THE STATE OF NEW HAMPSHIRE
BEFORE THE
NEW HAMPSHIRE SITE EVALUATION COMMITTEE

DOCKET NO. 2024-02

PETITION REQUESTING JURISDICTION AND OVERSIGHT OF
EVERSOURCE PROPOSED X-178 TRANSMISSION LINE
REPLACEMENT PROJECT

**Public Service Company of New Hampshire Responses to
Technical Session Data Requests**

THIS PLAN FOR REFERENCE ONLY.
NO REPRESENTATION OR WARRANTY IS
MADE AS TO LOCATION OF
BOUNDARIES OR OTHER POINTS OF
REFERENCE

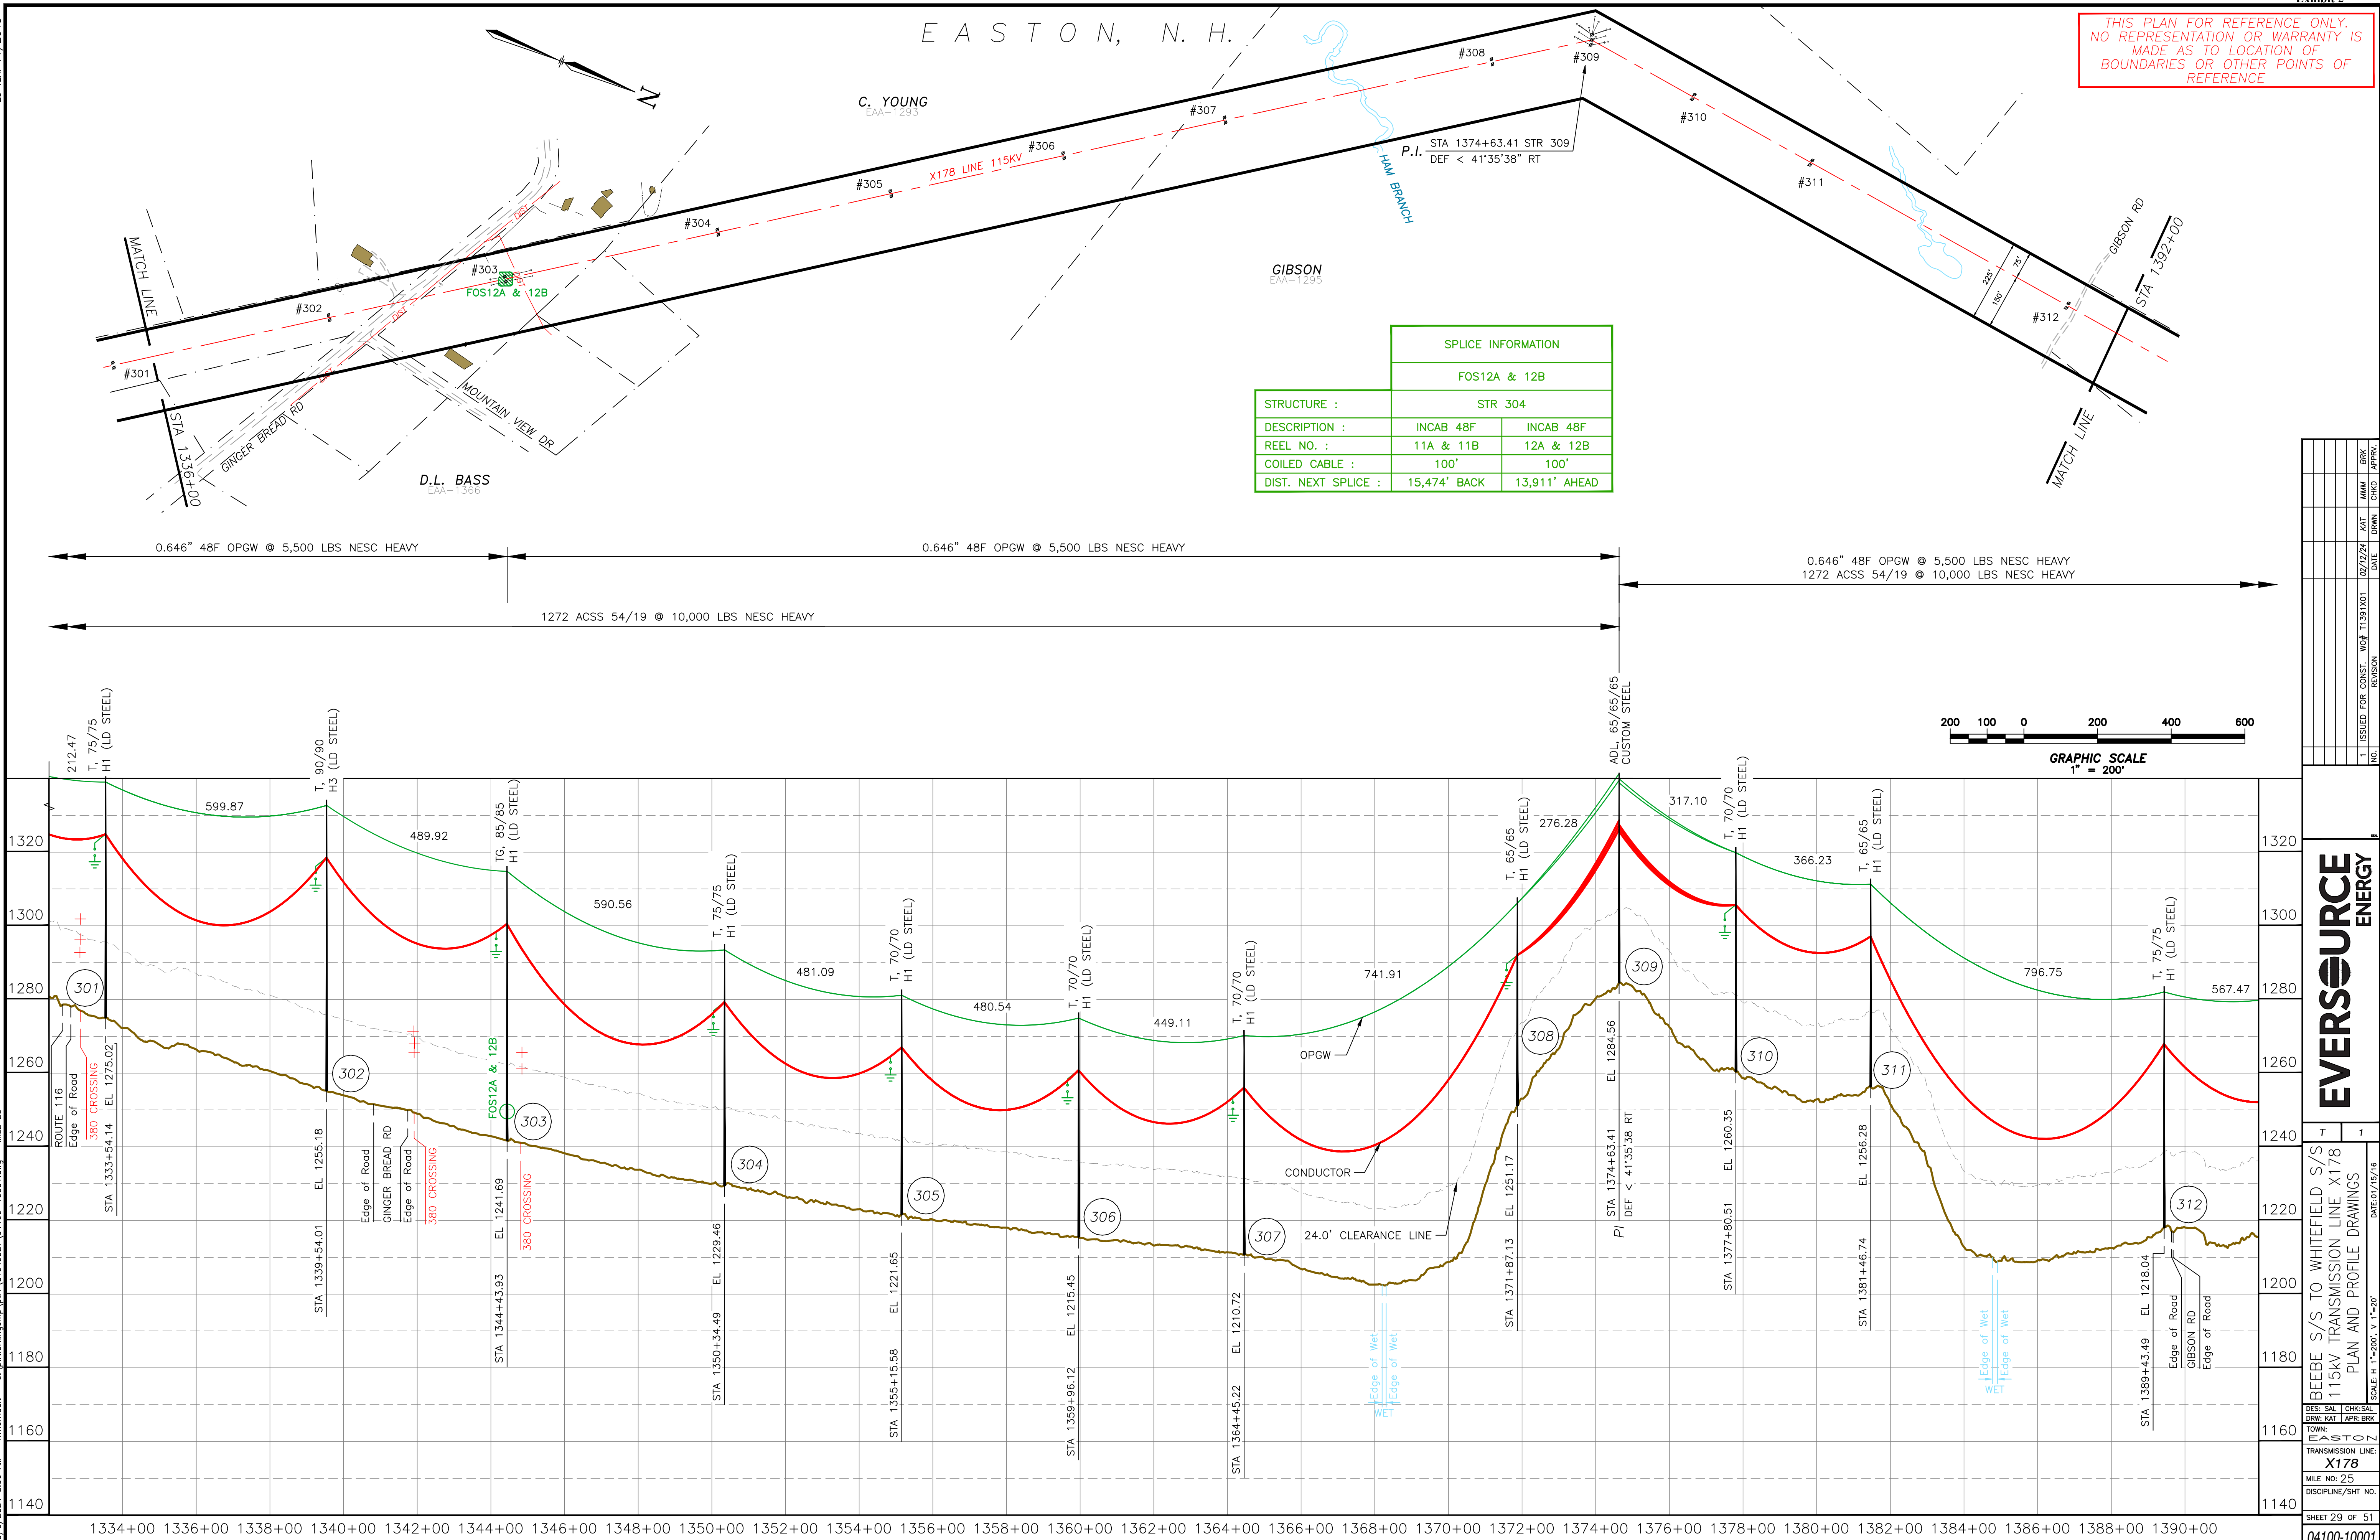
4. Provide profile drawings for the towns of Easton and Bethlehem.

Response: Copies of the profile drawings for the towns of Easton and Bethlehem will be filed as part of the revised Technical Report submitted to the NHSEC. For convenience, the profile drawings are provided to the Town's now as Attachment 1.

DESIGNED BY: CHW/GBS	DATE: 08/21/14
DRAWN BY: GBS	
TOWN: NA	
TRANSMISSION LINE: NA	
MILE NO: DISCIPLINE/SHT NO.	
SHEET 1 OF 1	
047943001

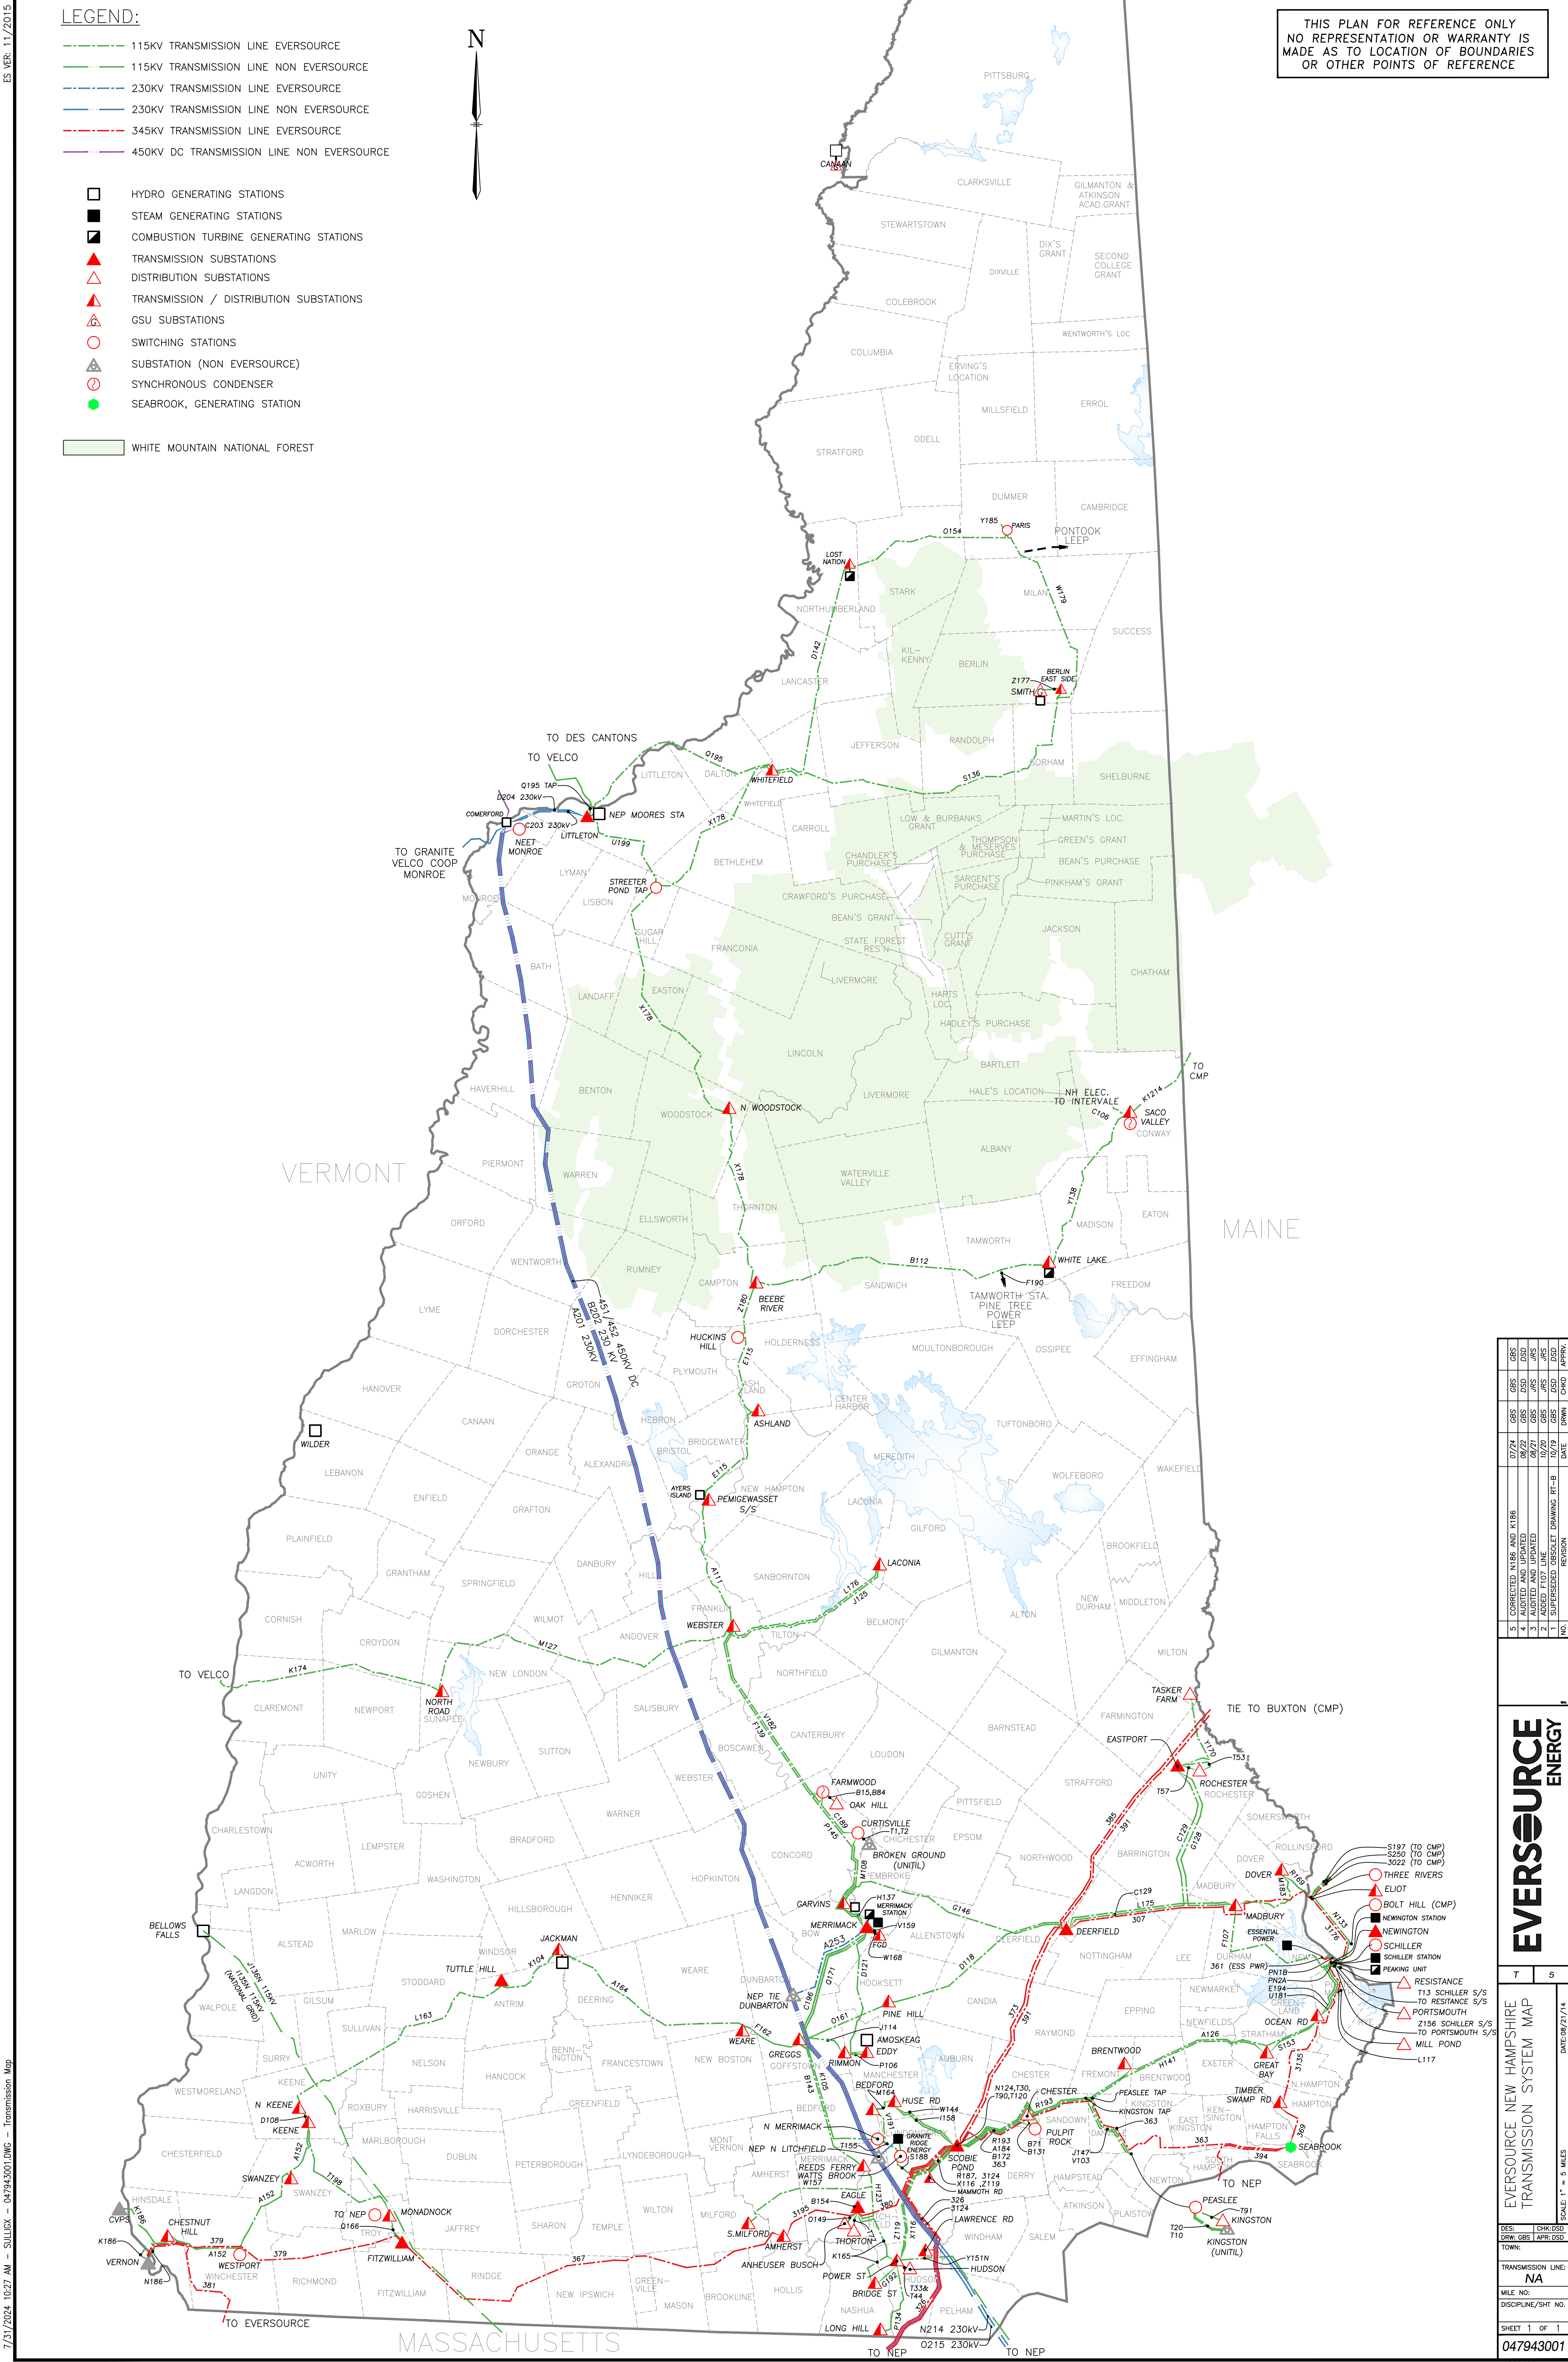
8. Provide a copy of a transmission system map.

Response: A map of the Eversource transmission system will be filed as part of the revised Technical Report submitted to the NHSEC. For convenience, a copy of the transmission system map is provided to the Town's now as Attachments 4.
